ElectorateOffice PortStephens - Proposed Tomago Cable Manufacturing Project

RE: Submission to Proposed Cable Manufacturing facility Application # 10_0039

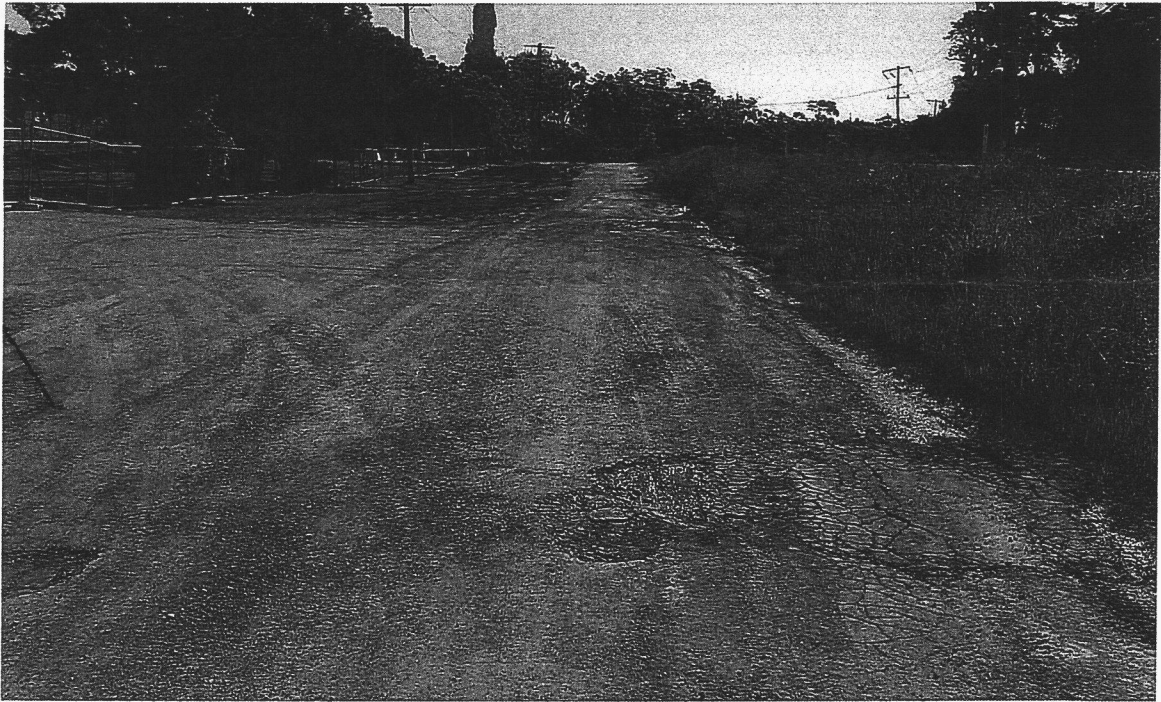
The western 500m is mostly two lanes but in its current state it has lengths that are only 4m wide of sealed surface. See Photo below.

The Complete failure of School Dve in front of the new Aus Grid Sub Station @ 37 School Dve due to construction works.

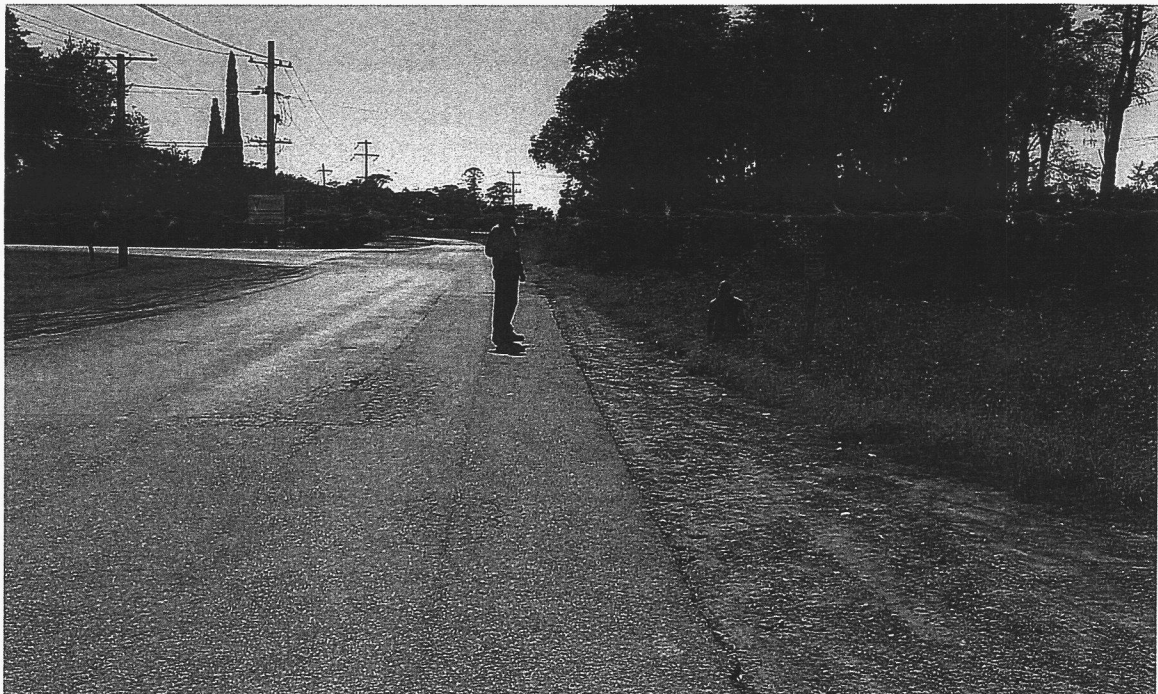
Lack of adequate drainage on the shoulders of the road. And also concealed drains in the shoulder
